R00DZ

**RECALL R00DZ
GRID HEATER WIRING MODIFICATION**

1999-2000 ALL AMERICAN BUSES WITH CUMMINS ISC FRONT ENGINE

FIGURE 1

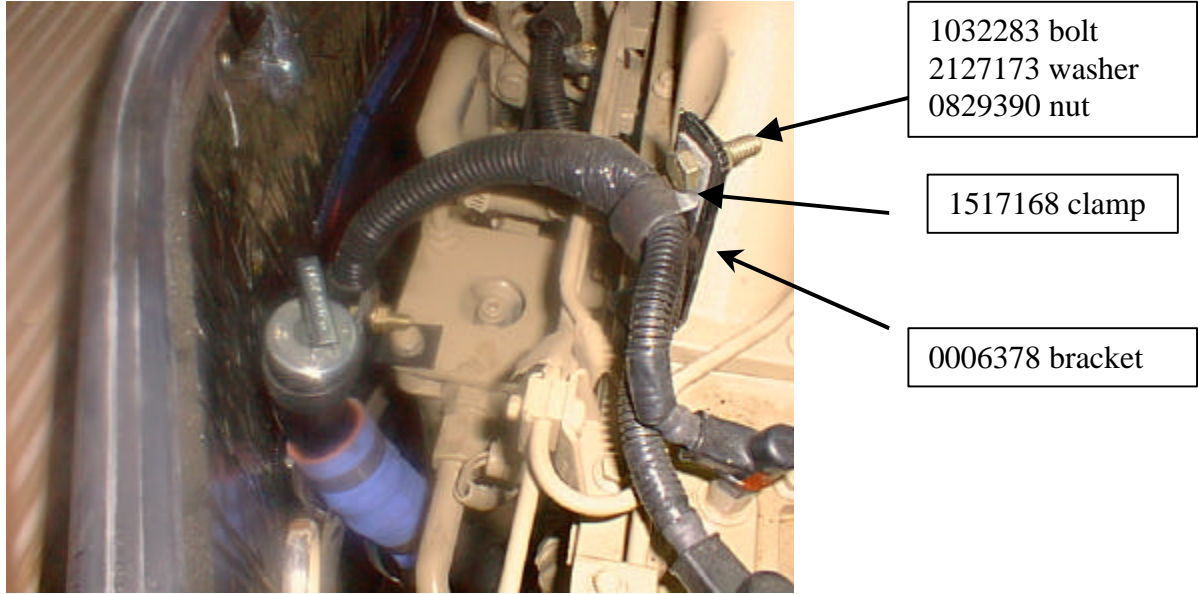
The defect involves the wiring harness for the combustion air intake grid heater on the subject buses. The grid heater wiring harness may rest against the engine or engine components and chafe through the wiring harness protective loom.

3. Remove Cummins bolt from left-hand rear of turbo inlet.
4. Install bracket (#0006378) in the direction shown in Figure 1 using Cummins bolt and torque to 18-ft. lb. Install insulated clamp (#1517168) around the wiring harness and attach to the bracket in the direction shown in Figure 1 using bolt (#1032283), flat washer (#2127173) & nut (#0829390).
